180 REDWOOD DR

ARCHITECTURAL REVIEW BOARD APPLICATION

RE: Tree Inspection of 180 Redwood Drive East Hills, NY 11576

LANDSCAPE PLAN
THE PODUSZCZAK RESIDENCE
 180 REDWOOD DRIVE
 EAST HILL, NY
 Sec: 2 Blk. Lot: 21

LANDSCAPE PLAN
THE PODUSZCZAK

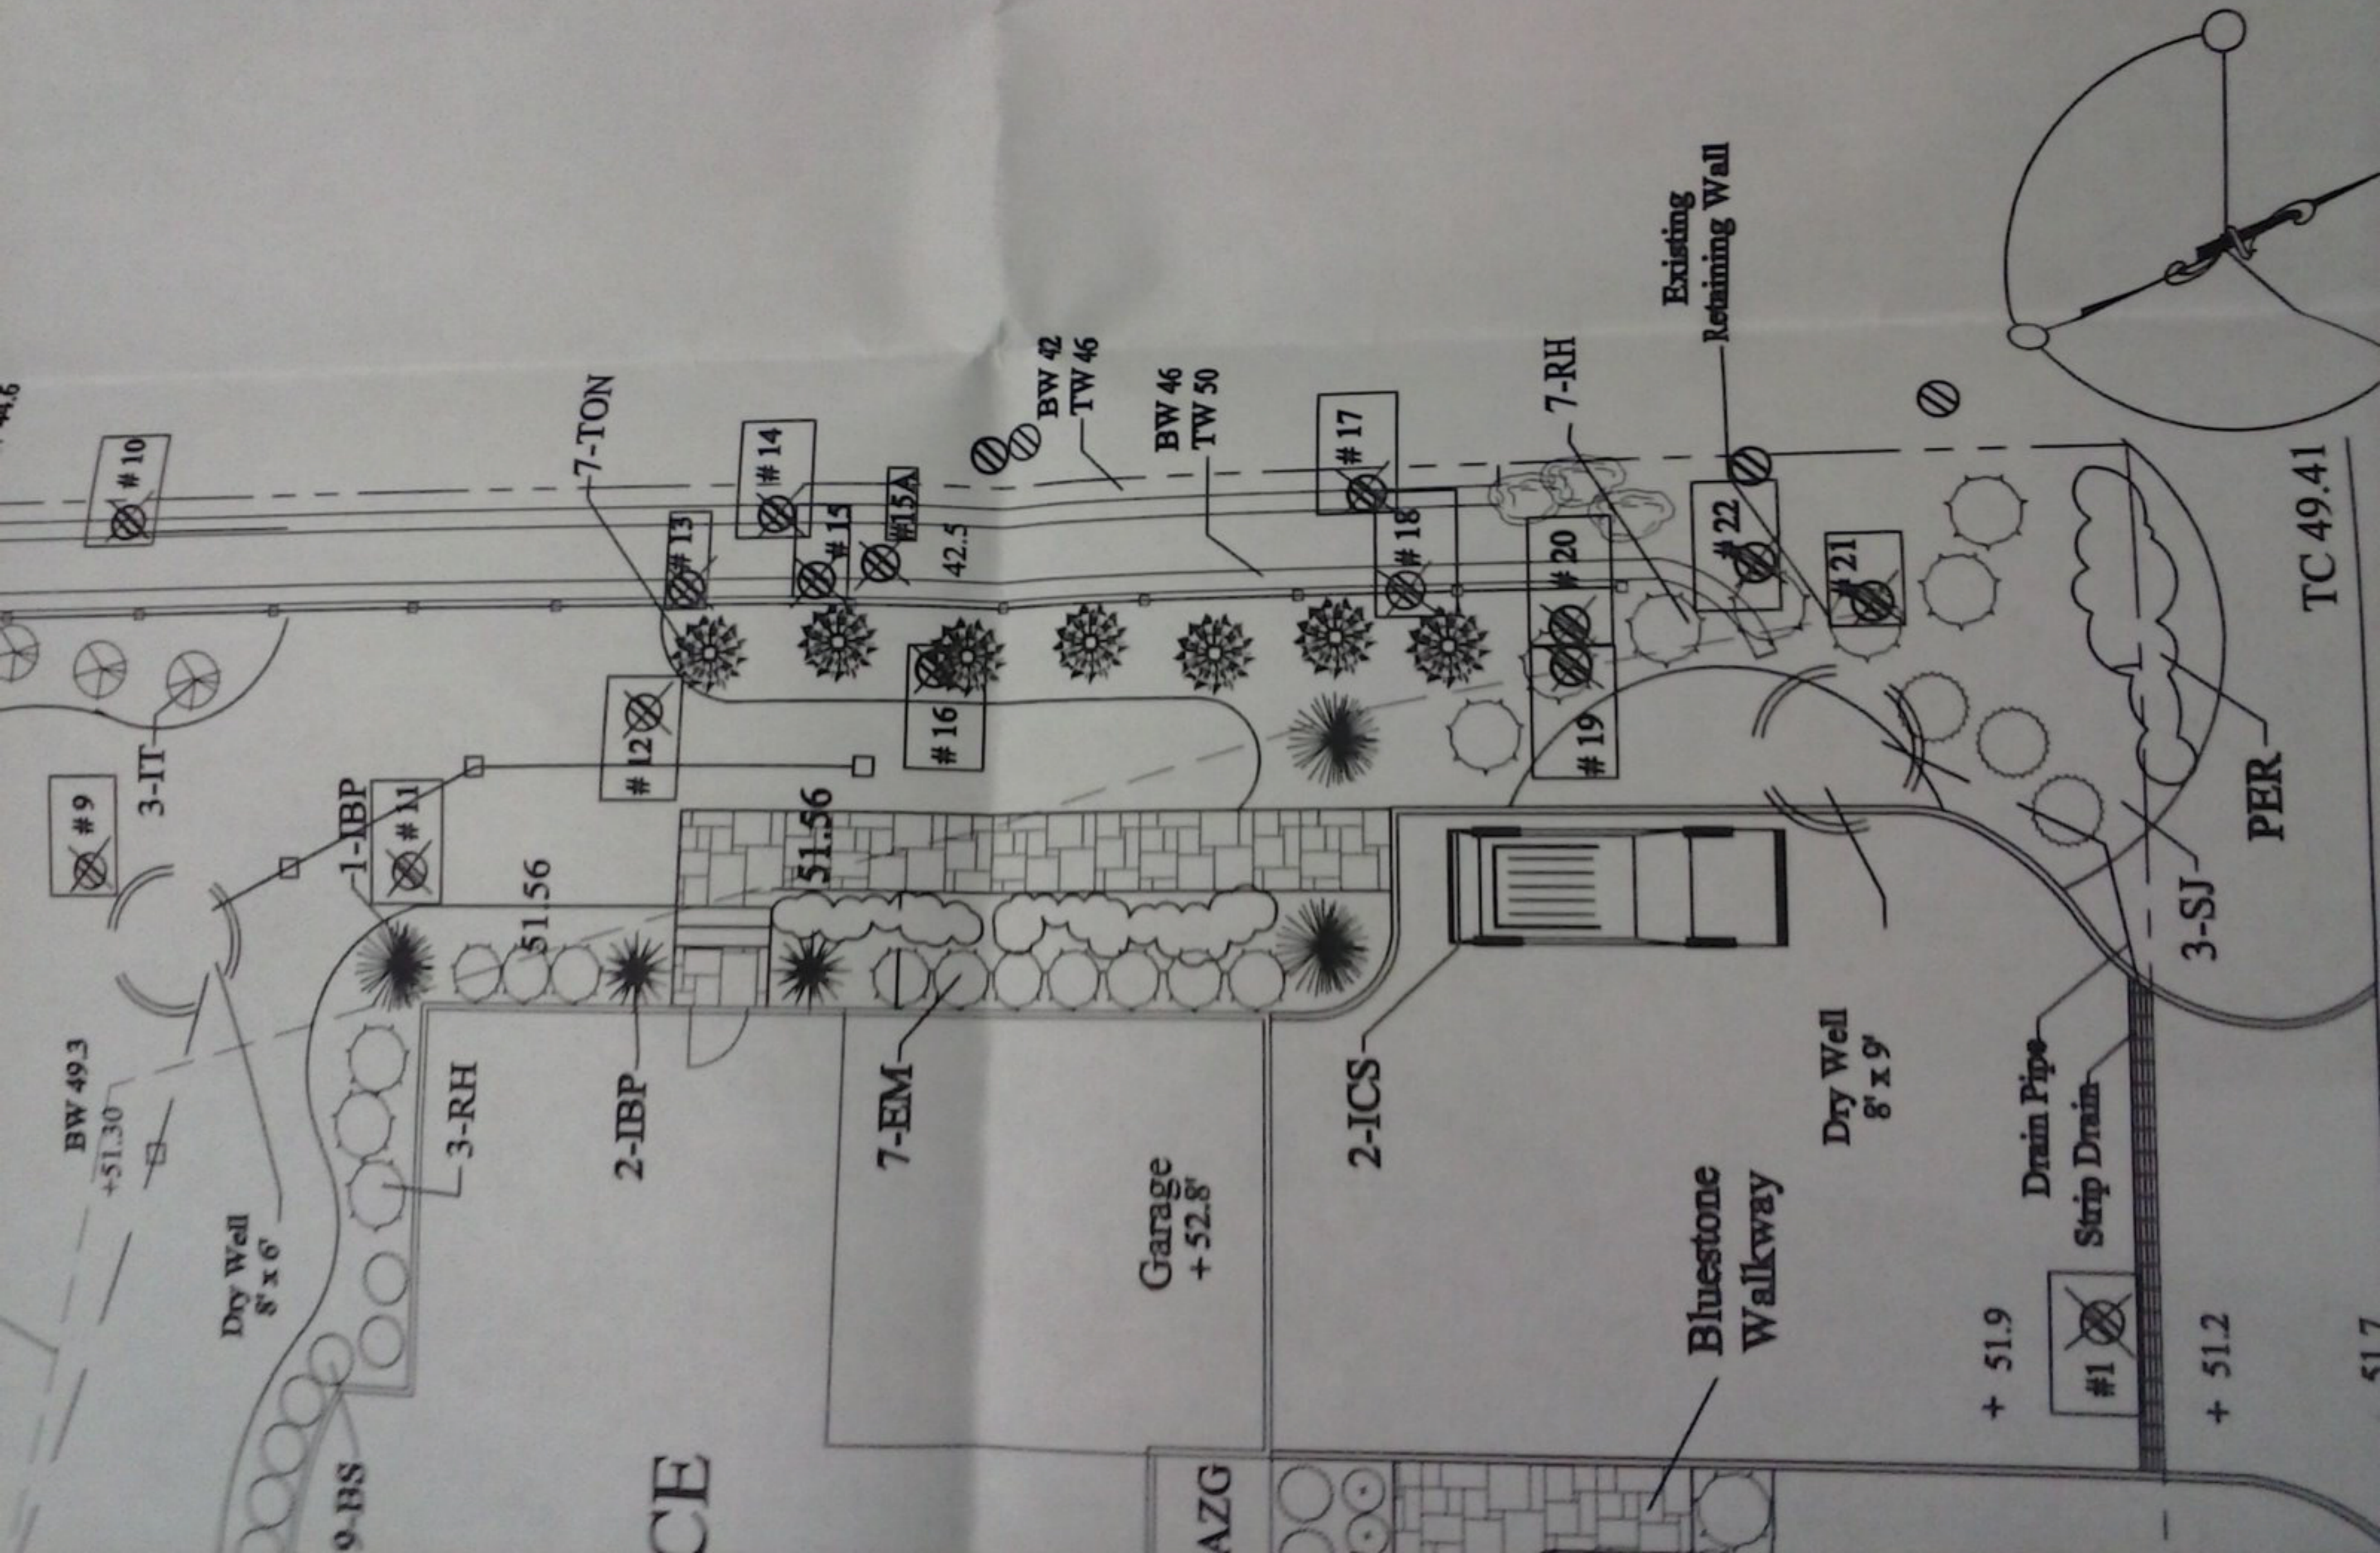
As per your request, I inspected the trees at 180 Redwood Drive. Many of these trees are covered in vines. These vines can be cut. Not all of these trees need to be removed.

These trees provide an important function in holding the extreme slope with their roots. Please see spreadsheet.

<u>Number</u>	<u>Species</u>	<u>Size caliper</u>	<u>Reason for Removal</u>	
1	Weeping Cherry	10"	Construction project	Tree is in the way of construction
2	Hemlock	dbl 10",11"	(Neglected vine covered trees)	Hemlock is in poor shape
3	Birch	10"		Birch tree leans toward house and covered in vines
4	Beech	8"		Tree is also a birch covered in vines and leans toward house
5	Oak	16"		Oak tree had previous storm damage and has a phototropic lean, covered in ivy.
6	Maple	dbl 15",16"		Maple tree is fine. Need not to be removed. Holds slope
7	Maple	dbl 12",12"		Maple tree is fine. Holds slope
8	Tree of Heaven	dbl 15",18"		This tree is not an ideal species but tree is in good shape. Needs to have vines cut at base'
9	Locust	24"		This locust is covered with vines but is healthy and its roots help to hold this steep slope vines should be cut but tree can stay
10	Locust	12"		This locust has a lean, is not in great health and should be removed

11	Locust	19"		This locst is straight, healthy and its roots hold the slope
12	Locust	15"		This tree leans has been strangled by vines and has defects. It should be removed
13	Locust	10"		This tree has no top and can be removed
14	Locust	22"		This tree is in poor shape and can be removed
15	Locust	15"		This tree has trunk defects and can be removed
15A	Locust	10"		This tree is not in great shape and can be removed
16	Locust	dbl 20",18"		This tree has a split in te trunk and can be removed
17	Locust	18"		This tree is rotted at the base and should be removed
18	Locust	16"		This tree is in good health. The roots hold the slope
19	Locust	10"		This tree is in good health and can stay
20	Maple	21"		This tree is a locust that leans anD should be removed
21	Maple	10"		This tree has limited space to grow and is close to new driveway
22	Oak	12"		This tree leans and is too close to the driveway
